# National Committee on Uniform Traffic Control Devices

Item Number: 25B-RR-01

## NCUTCD RECOMMENDATION FOR CHANGES TO THE MANUAL ON UNIFORM TRAFFIC CONTROL DEVICES

**COMMITTEE / TASK FORCE:** Railroad and Light Rail Transit Technical Committee  
**ITEM NUMBER:** 25B-RR-01  
**TOPIC:** Removal of Defined Length and Width of Retroreflective Strip  
**ORIGIN OF REQUEST:** Railroad and Light Rail TC  
**AFFECTED SECTIONS OF MUTCD:** 8D.03, Figure 8D-1

**Figure 8D-1. Composite Drawing of Active Traffic Control Devices for Grade Crossings Showing Clearances**

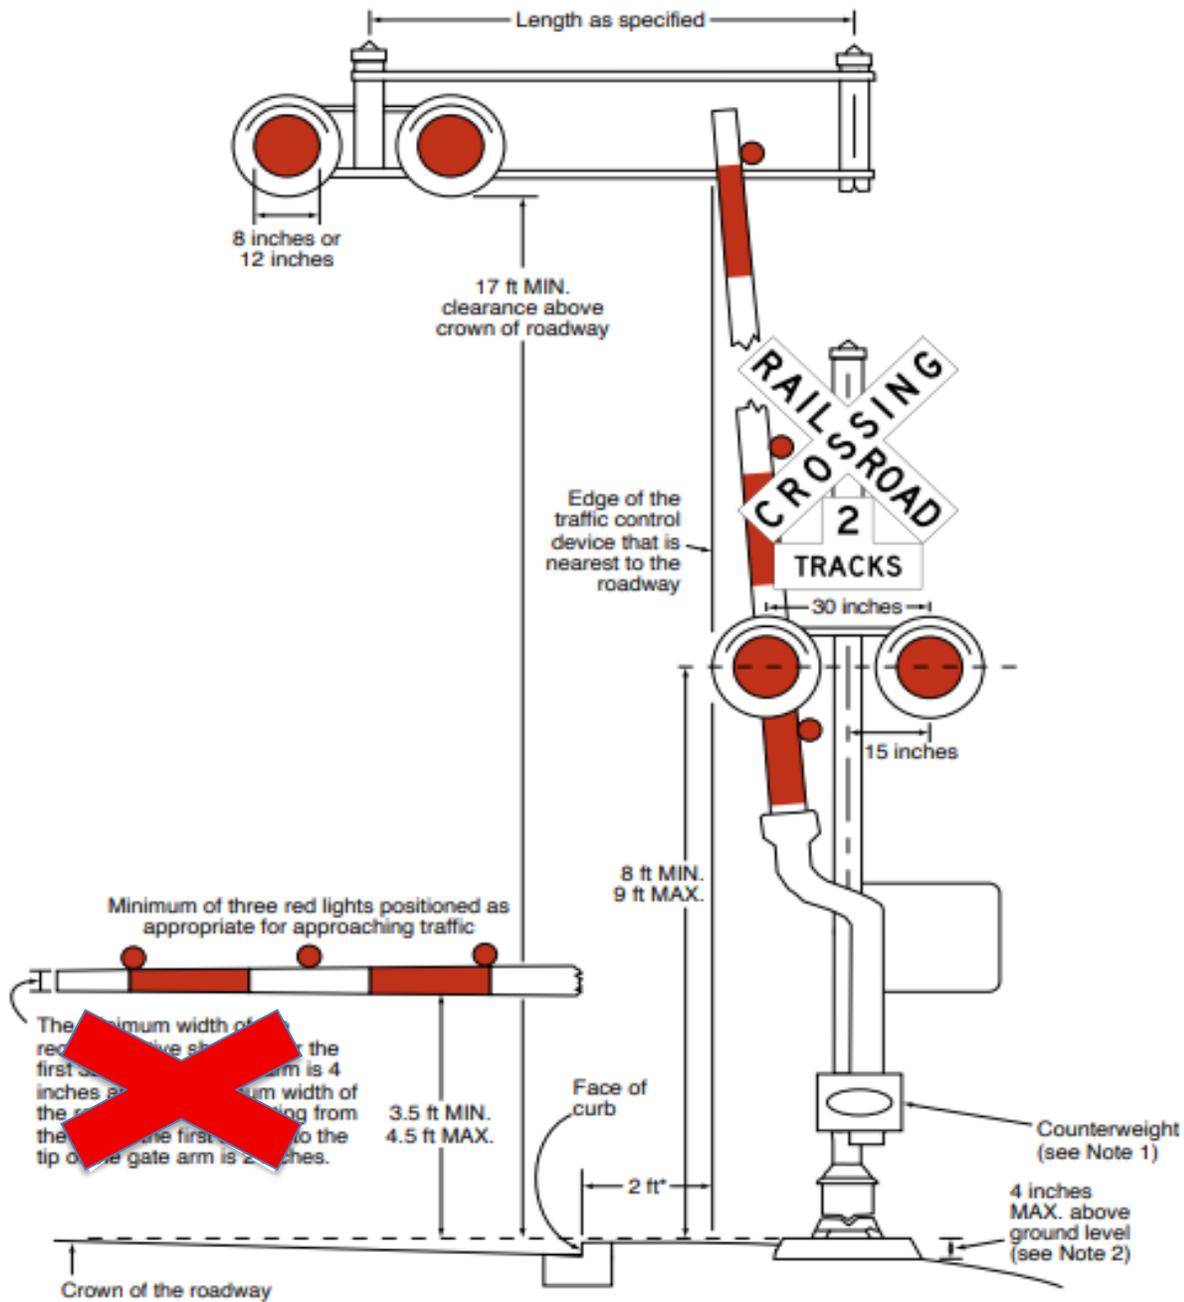
This proposal is for the change in section 8D.03 to provide for the requirement of the width of reflective material to include the entire gate arm and be determined by the width of the gate section rather than an arbitrary length.

70 05 Gate arms shall be fully retroreflective on both sides along the entire length and shall have  
71 vertical stripes alternately red and white at 16-inch intervals measured horizontally. The height of  
72 the retroreflective sheeting when the automatic gate is in the down position shall be at least 4 inches.  
73 ~~The width (which becomes the height of the retroreflective sheeting when the automatic gate is in~~  
74 ~~the down position) of the retroreflective sheeting on the front of the gate arm shall be at least 4~~  
75 ~~inches for the first 32 feet of gate arm length measured from the center of the gate mast. The front of~~  
76 ~~the gate arm beyond 32 feet to the tip of the gate shall have retroreflective sheeting at least 2 inches~~  
77 ~~in width.~~

79 05a Where a section of the gate arm is less than 4 inches in height when the automatic gate is in the down  
80 position, the retroreflective sheeting on that portion of the gate arm may be reduced to the height of the  
81 gate arm, but at no point less than 2 inches.
